Dunsbury Park
APP/17/00866 – Reserved matters

Landscaping addendum

Reserved Matters – Cut & fill, site layout

Dunsbury Park

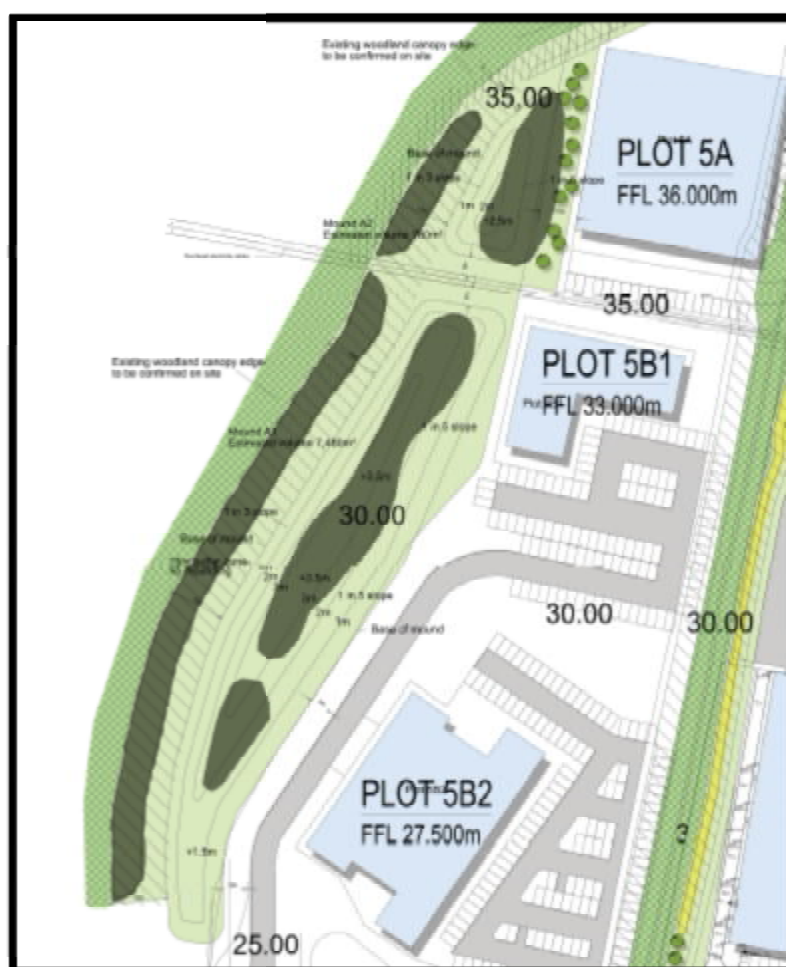
We have concerns regarding the final building heights for plots 5 and 5A where the maximum building height (AOD) exceed the parameter plan limit. The proposed increase on the building heights has the potential to have a greater impact on the local landscape, which has not been taken into account as apart of the original landscape visual impact assessment. The submitted alterations to the LVIA within the planning statement is not deemed sufficient to understand how the increased building height will effect the landscape. As such we will need the original LVIA updated (with the changes highlighted) to reflect the new building height, this needs to be accompanied with a revised conclusion and supporting mitigating strategies that feed into the landscape strategy.

To mitigate the height increase we would recommend internal tree planting that, once mature will help to soften the views into the site. North and south of plot 5 and west of plot 5A would be deemed appropriate locations for internal tree planting.

- 5.2 Hedgerow buffers were also proposed along the northern boundary of what is now Plot 5, and running alongside the hedgerow that lies in a north / south direction splitting the plots north of Fitzwygram Way. To tie in with the plot layouts being sought as part of this reserved matters application, a more detailed landscape plan has been prepared for the land to the west of Park Lane taking on board the comments made by the HBC landscape officer in terms of the locations of additional planting to help mitigate increased building heights.
